2 Type of change

- Standards update and modification of approval marks.

Engineering Documentation					PCN 6061 Appliance Inlet		
owner	creation date	release date	released by	change order no	rev	page	D10-025-138
lokhanze	28.04.2018	09.11.2018	limachcl	2016052	A	1 of 2

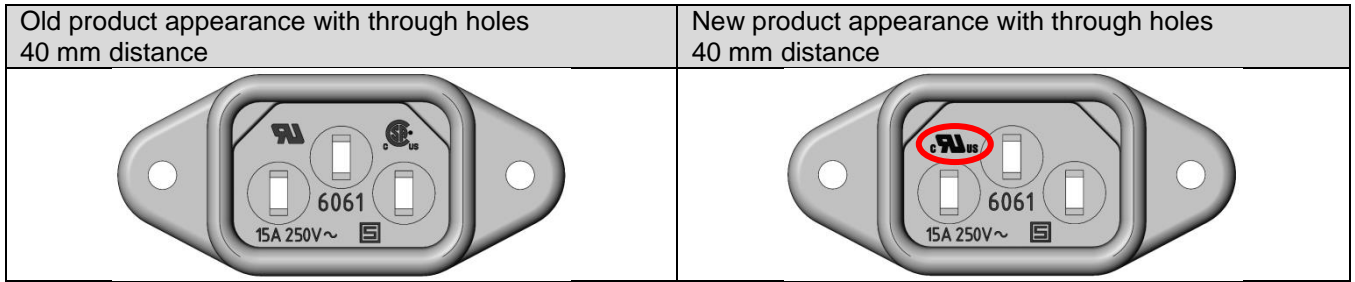
Old product appearance with countersunk holes 36 mm distance	New product appearance with countersunk holes 36 mm distance
Old product appearance with countersunk / through holes / 40 mm distance / screw terminal	New product appearance with countersunk / through holes / 40 mm distance / screw terminal
Old product appearance V-Lock version protection class I and II	New product appearance V-Lock version protection class I and II
Old product appearance with countersunk holes 40 mm distance	New product appearance with countersunk holes 40 mm distance

Old product approval UL and cCSAus mark	New product approval Combined UL/CSA approval according to UL 60320-1
Old Label	New Label

Standards update according to the new UL/CSA 60320-1

Form	Yes	Replacement of UR and cCSAus mark with combined cURus mark.
Fit	No	-
Function	No	-
Manufacturing	No	-
Label	Yes	Replacement of UR and cCSAus mark with combined cURus mark.
Packaging	No	-
